Planning and Land Use Committee Report

Subject: **Development Permit Application with Variances #000348 for 815 Queens Avenue** - To increase the permitted height and site coverage and to decrease required setbacks and open site space to construct an eight-unit apartment building

DRAWING TITLE:	BUILDING SECTION
VIA JOB #:	13-10
DRAWN:	N.J.A.
CHECKED:	A.L.
SCALE:	1/4" = 1'-0"
PRINT DATE:	29 JAN 2013
DRAWING #:	A3.1r4

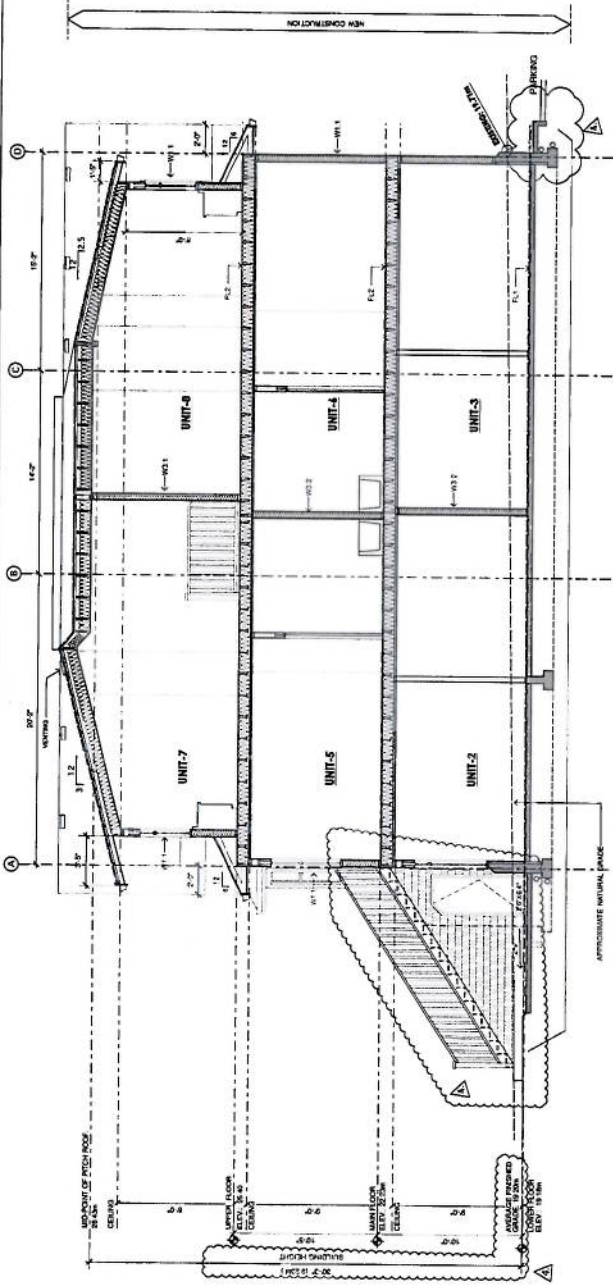
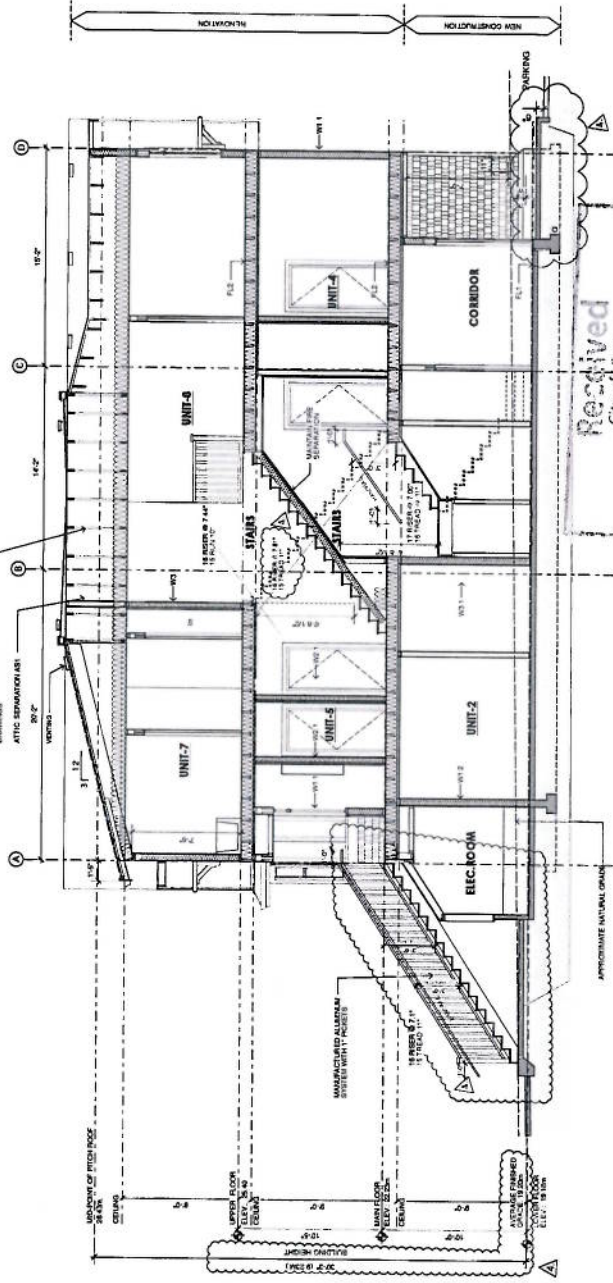
The applicant proposes an increase in building height of 0.43 m. This is a result of a drafting error by the applicant at the design phase. Staff acknowledge that the proposed building will be slightly larger and taller than some houses on Queens Avenue; however, the building height is mitigated by the proposed building form and neighbouring buildings. By retaining much of the existing dwelling, the character of a large single family dwelling is maintained while the roof form and mix of exterior materials serve to break down the proposed building's mass. Moreover, the proposed building is not out of scale with the immediate streetscape context of the site, including a two-storey apartment building and church. Staff recommend that the Committee support the proposed increase in height.

The building height as per the R-71 zoning bylaw is 8.80m. Our requested variance is for 0.58m, resulting in a proposed building height of 9.38m. This difference in height is a result of two items which have come up during the course of construction; however, it is important to note that the geodetic height of the main level will remain unchanged from the height indicated on the original Rezoning and Development Permit Application:

- (i) The as-built main floor ceiling height measurement was inaccurately calculated in the drafting phase of the building's schematic design. The floor-to-floor height of the main level is in fact 0.15m greater than what was previously noted.
- (ii) Secondly, the average finished grade of the site ended up being lower than expected as a result of excavating and grading for the surface parking area in the rear yard. The average finished grade is now 0.32m lower than previously expected. Maintaining a lower finished grade for the site also allows us to avoid using addition stairs within the front walkway leading up to the front entry stairs as well as avoiding stairs leading down to and away from the second exit door at the rear of the building.

VISION PROPERTIES INC :: 815 QUEENS AVENUE :: LP.01 :: landscape layout ::

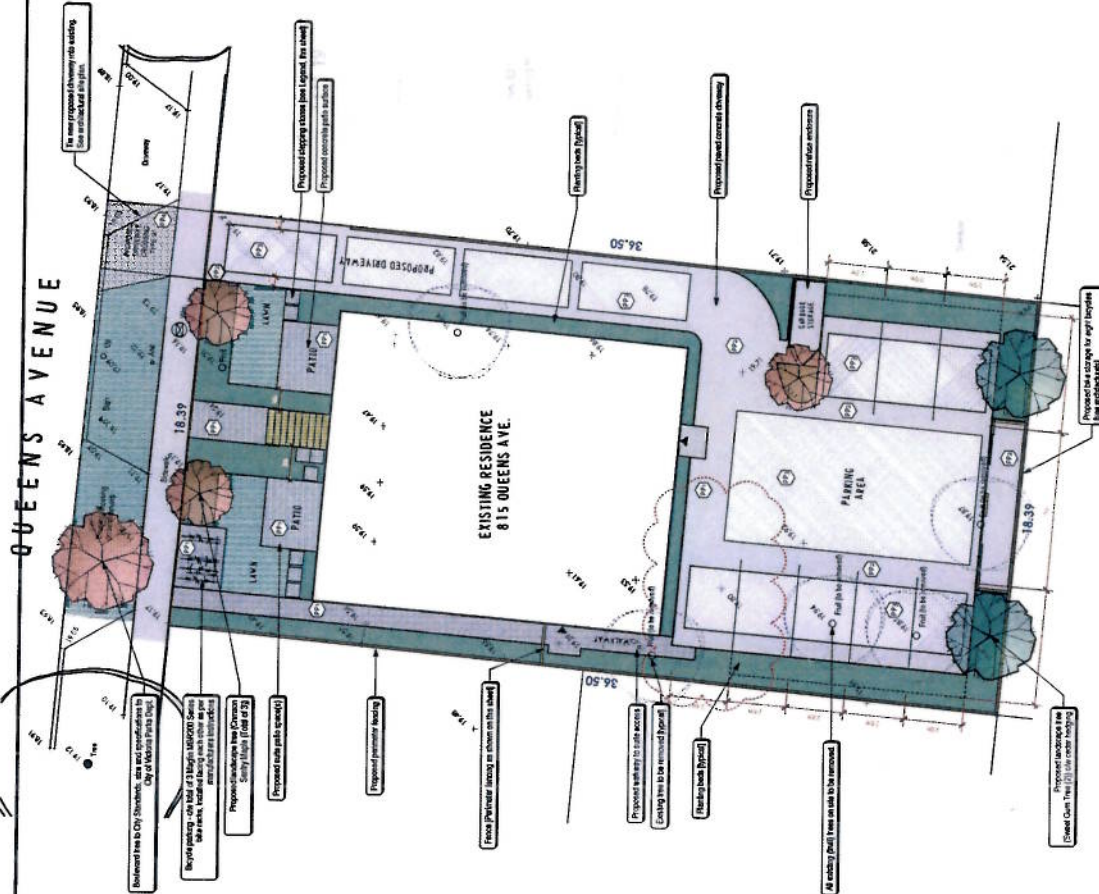
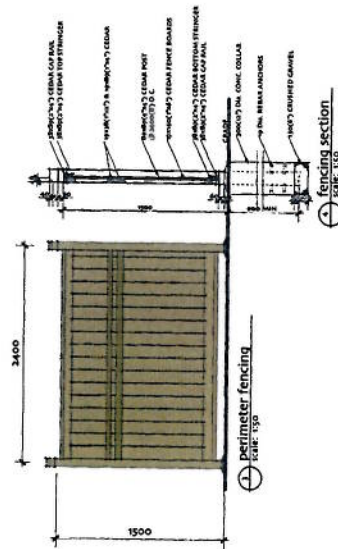
- The applicant proposes to replace the drive-aisle and parking area surface with concrete instead of asphalt. Staff recommend this change be supported. The applicant further proposes to replace paving stone inserts in the concrete with stamped concrete. Given the high site coverage and low open site space requirements in this zone, staff recommend that a permeable surface be installed in these portions of the drive-aisle and parking area.

Additionally, the applicant proposes to replace the drive-aisle and parking area surface with concrete instead of asphalt. Staff are supportive of this change. The applicant further proposes to replace paving stone inserts in the concrete with stamped concrete. Given the high site coverage and low open site space requirements in this zone, staff recommend that the Committee require a permeable surface be installed in these portions of the drive-aisle and parking area.

- revision of the paving treatment in the rear parking area and driveway to provide permeable unit pavers (or similar) instead of stamped concrete, to the satisfaction of the Director of Sustainable Planning and Community Development
- revision to the parking layout to reduce the proposed number of parking stalls from 8 stalls to 7 stalls and to enhance the landscaping in place of the eliminated parking stall, to the satisfaction of the Director of Sustainable Planning and Community Development
- Plans date stamped "Development Permit #000348, dated February 6, 2014"
- Final plans as amended to be in accordance with the plans identified above to the satisfaction of the Director of Sustainable Planning and Community Development.
